**MEETING AGENDA.....PLANNING BOARD
TOWN OF CORTLANDT
6:30 TUESDAY EVENING*
APRIL 1, 2025**

**RE: Floor & Decor
Proposed Floor & Décor
Site Plan Amendment
PB 2025-4
2094 East Main Street
Tax ID 24.13-2-9
Town of Cortlandt
Westchester County, NY
DEC# 5079 24-04330**

Below are sequential responses to the comment letters prepared by and received from the Town Professionals as they relate to the Site Plan Amendment:

PRELIMINARY AND FINAL SITE PLAN

Plotted: 03/20/25 - 2:25 PM, By: aventurini, Product Ver: 25.0
File: \\spsc.local\cadd\projects\5079 floor and decor\24-04330 corlandt_ny\dwg\Site Plans\507924\43305S3.dwg, 05 SITE PLAN

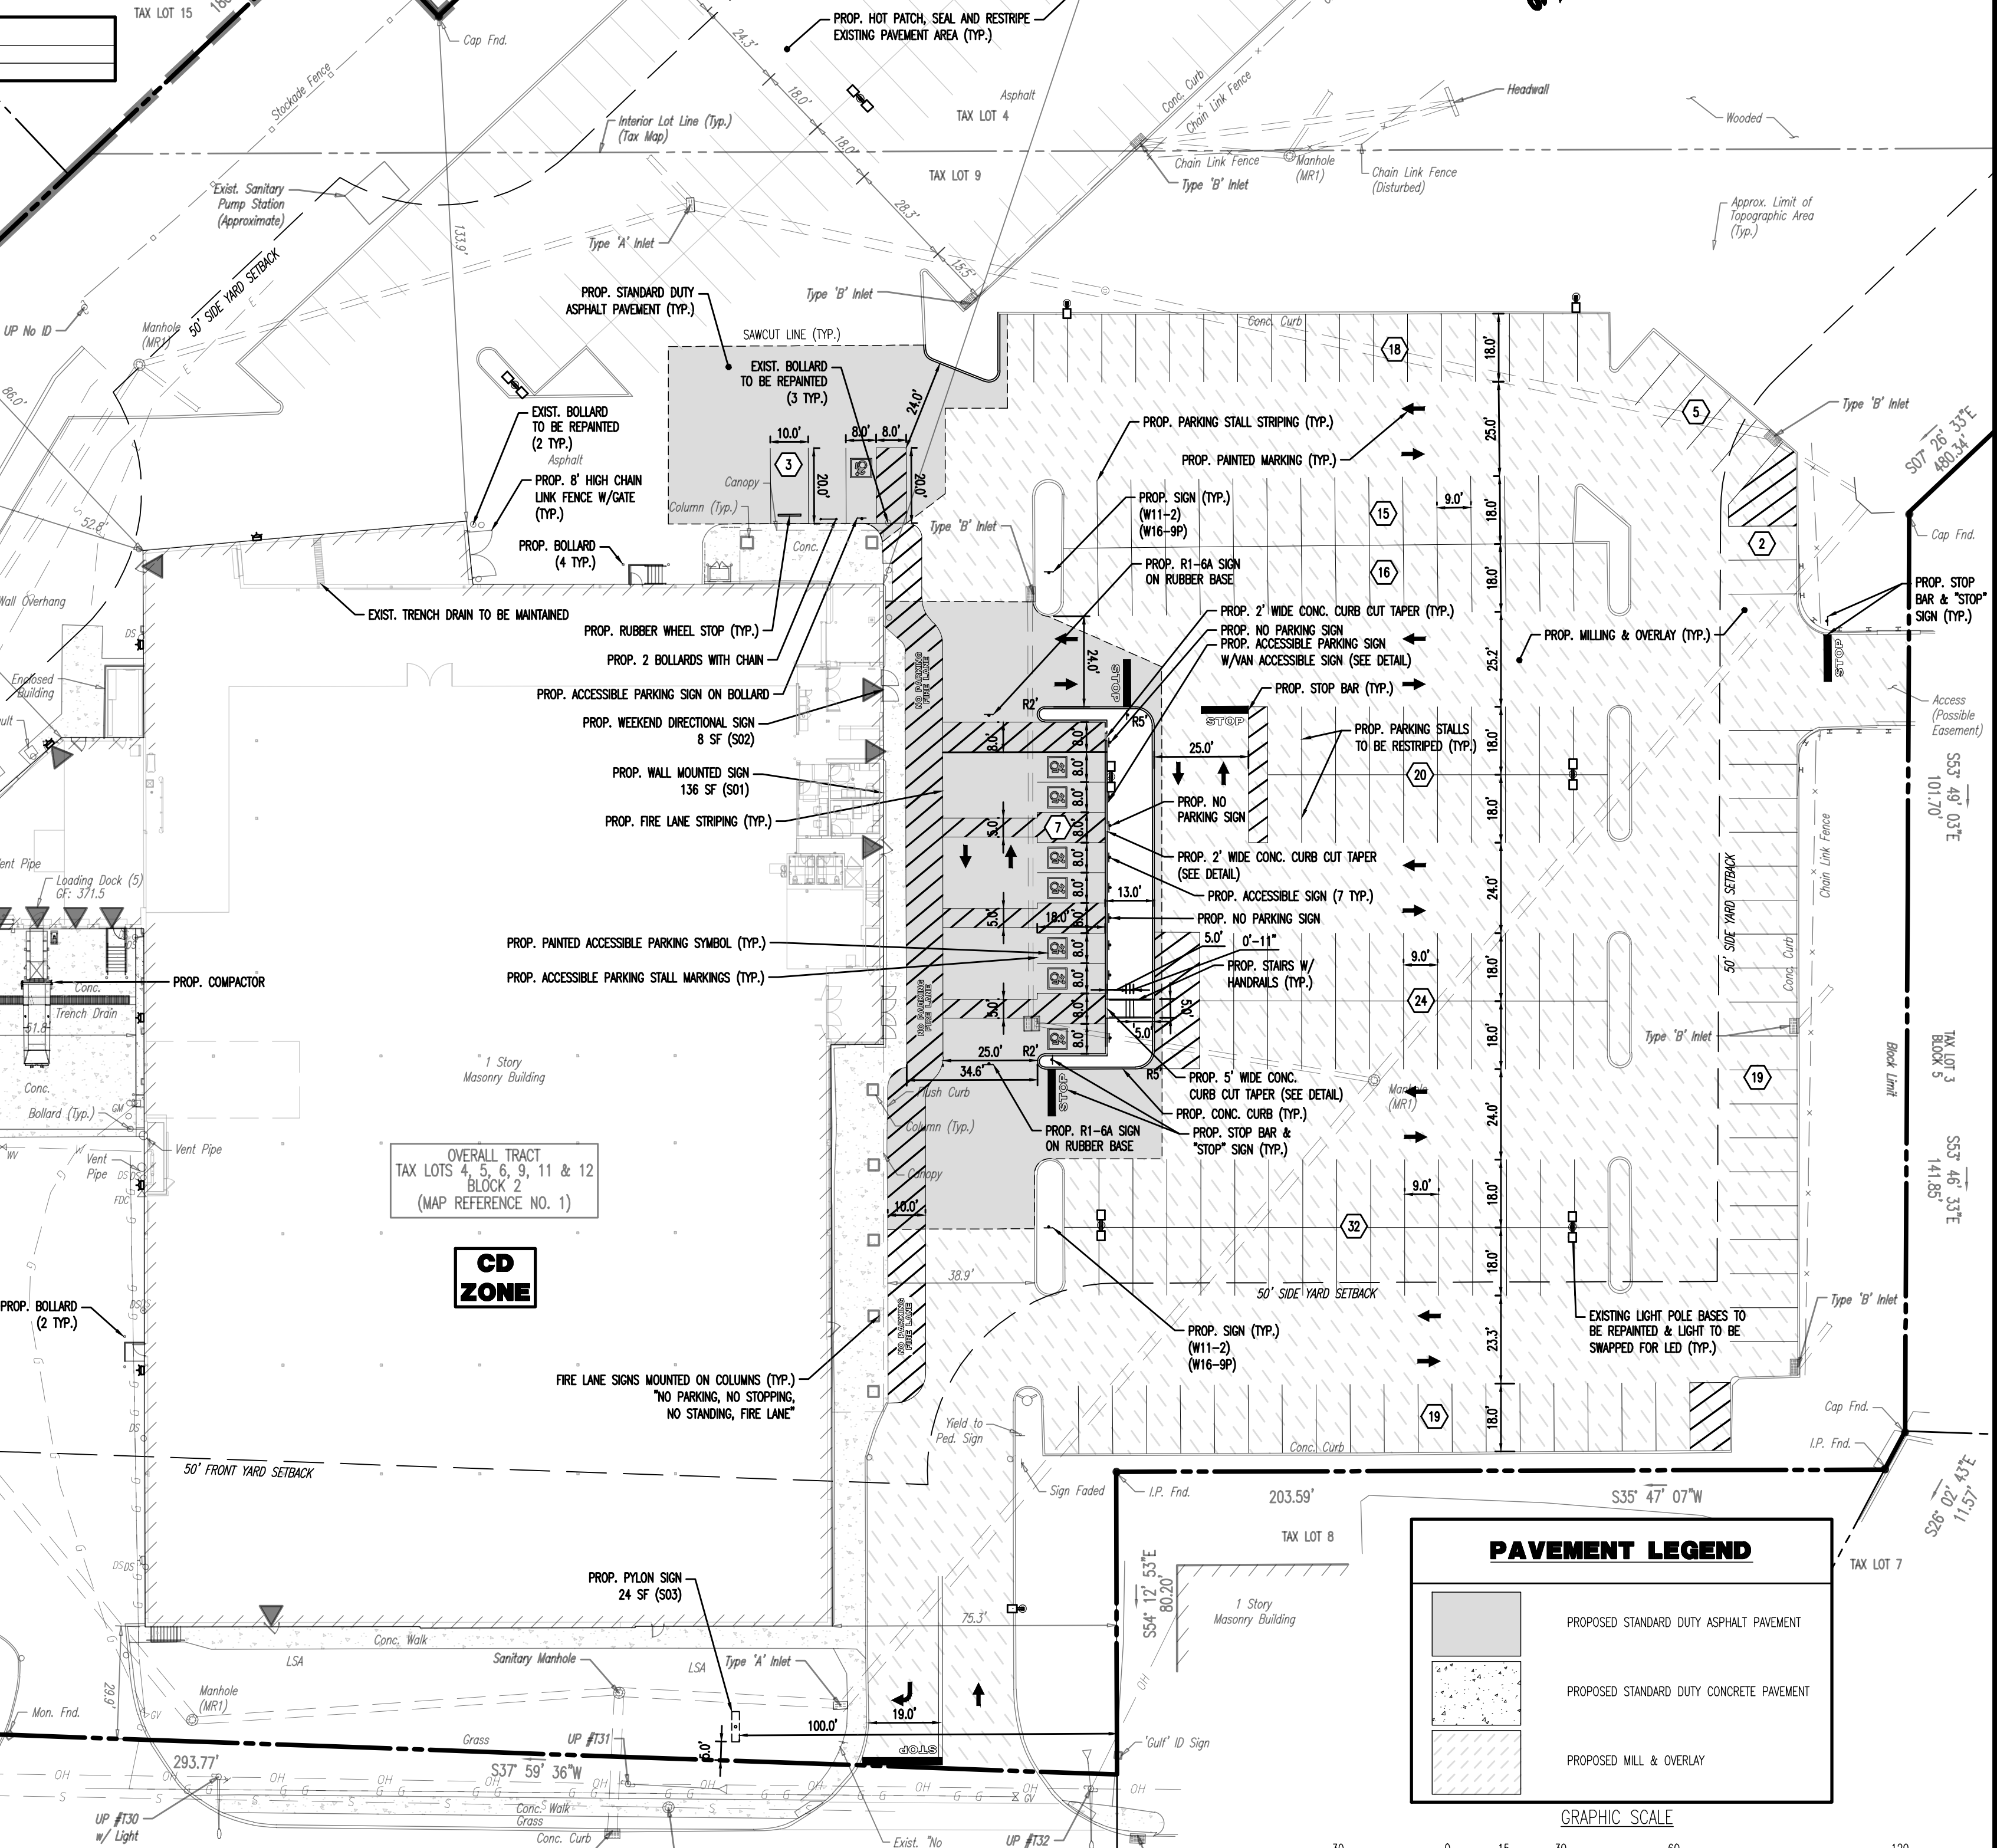
1. There are regulated FEMA flood ways onsite. Revise the site plan to locate the 100-year flood plain and 500-year flood plain. Reference and indicate FIRM Panels and any noted base flood elevations.

2. Add appropriate signage that restricts left turns from the site onto Route 6 / Cortlandt Boulevard. Provide details of the same.

Add a note to the plan that all garbage and recycling services shall be from private carting companies. The Town of Cortlandt will not serve the site.

A note has been added to the Site Plan stating “BASED ON FEMA FIRM MAP, MAP NUMBER 36119C0017F, EFFECTIVE DATE SEPTEMBER 28, 2007 AND AS REFLECTED ON THE REFERENCED PROJECT SURVEY, AND EXISTING CONDITIONS PLAN, PORTIONS ARE LOTS 5 AND 6 ARE WITHIN ZONE AE AND ZONE X. THE FLOOD ELEVATION FOR THESE LOTS IS APPROXIMATELY ELEV. 298.5. AS NOTED IN THE GRADING PLAN, THE EXISTING FINISHED FLOOR OF THE BUILDING IS APPROXIMATELY ELEV. 317.5.”

An existing “No Left Turn” sign is indicated on the Site Plan.

A note has been added to the Site Plan stating same.

SHEET No: **9** OF 14
Rev. #: 3

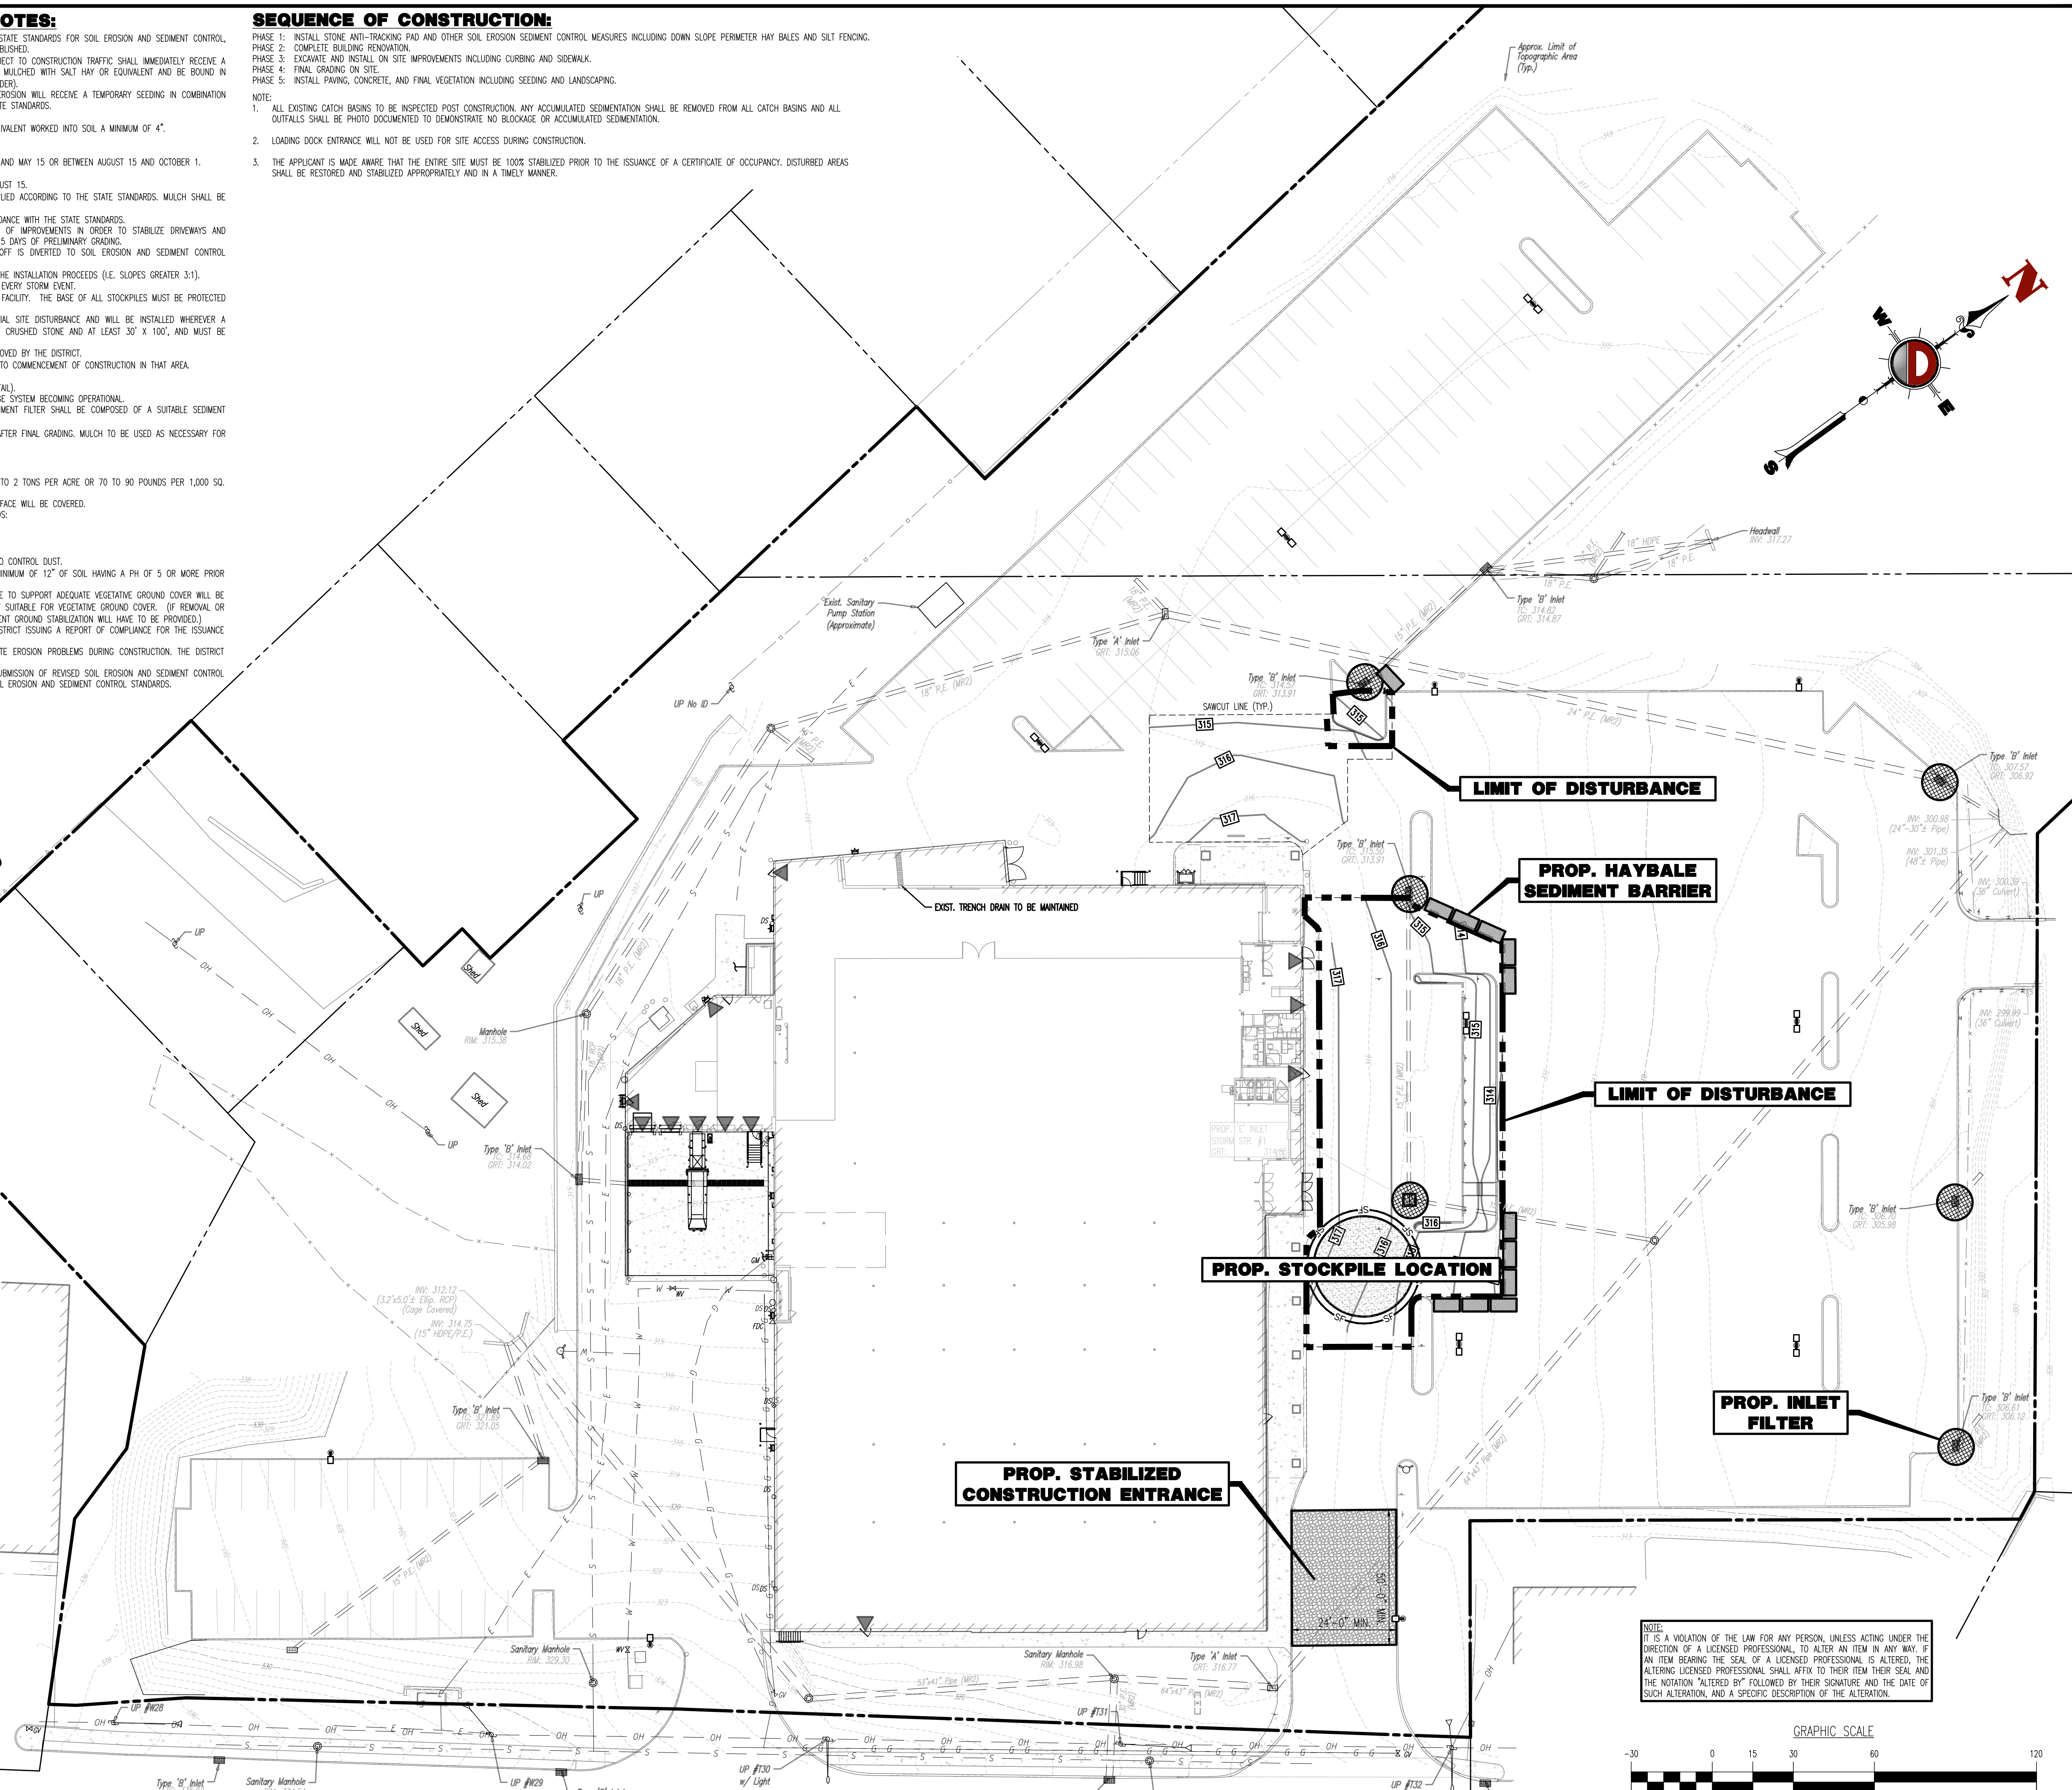
6. The erosion and sedimentation control plan shall be revised to protect the trench drain across the loading dock(s), include controls along the perimeter of the existing filtration basin, and note requirements for inspection of catch basins and sweeping.

Clarify why the construction entrance is right at Route 6? Can this not be installed interior to the site to allow for a bit of runout? Also note that the loading dock entrance will not be used for site access during construction. Otherwise, an additional construction entrance will be required.

Is a typical stone construction entrance suitable for this site? Perhaps an alternative track out control is warranted since soil disturbance is extremely limited.

No earthwork or disturbance is proposed within the vicinity of the loading dock area. Additionally, no earthwork is proposed within the vicinity of the existing filtration basin. A note has been added to the Soil Erosion and Sediment Plan stating that all catch basins will be inspected post construction, and any accumulated sedimentation shall be removed, and outfalls shall be photo documented.

Construction entrance has been revised to be further away from Route 6. No earthwork disturbance is proposed near the loading dock entrance. As the site disturbance is limited to the northern side of the site, the loading dock entrance will not be used for site access during construction of the site improvements.

Soil disturbance is very limited as part of the redevelopment. A typical stone construction entrance is proposed as recognized in accordance with the New York State Standards and Specifications for Erosion and Sediment Control, "Bluebook".
